October 12, 1979
Fort St. Vrain
Unit No. 1
P-79235

Subject: Fluctuation Testing
and Revision of RT-500

GA RT -500 Revision G

RT-500-G
Sheet 1 of 17

FIG. 1. REQUIRED MARGIN ON ALLOWABLE MISMATCH
(L.C.O. 4.1.7 LIMIT - TEXT)

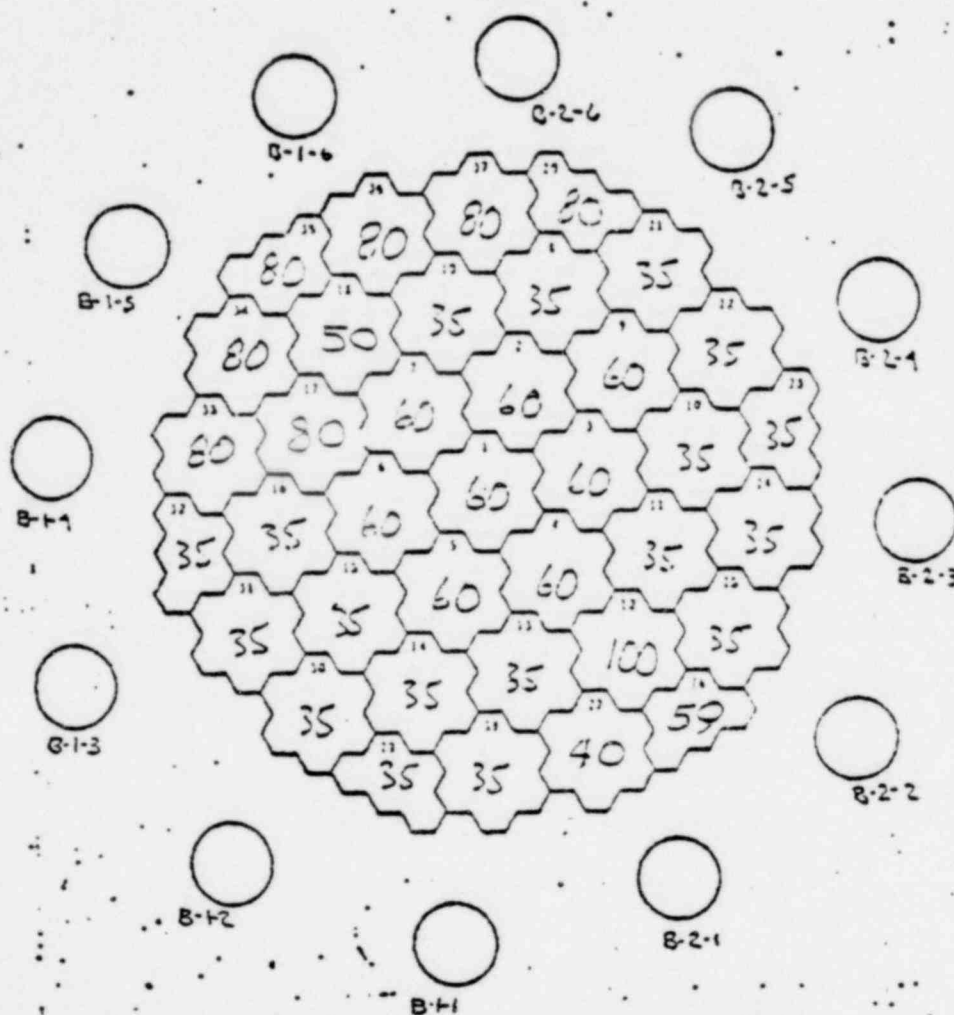
D 3. In order to minimize the chance of getting into a degraded performance condition during fluctuations, the maximum region outlet gas temperature during steady state conditions shall be limited as follows: From previous fluctuation data, it was noted that the following core regions exhibited the most severe temperature changes during the fluctuation: Regions 1, 2, 3, 4, 5, 6, 7, 9, 12, 20, 33, 34, 35, 36, and 37. All of these regions must be kept at least 60°F, 80°F, or 100°F below the allowable temperature limit of LCO 4.1.7 as shown in Figure 1. All other regions must be kept at least 35°F below the allowable limit.

E NOTE: The margins per Figure 1 are based on cycle 1 experience. When fluctuations are observed in cycle 2, the regions that exhibit the largest temperature variations may be different. As differences, if any, are observed, Figure 1 will be administratively revised accordingly.
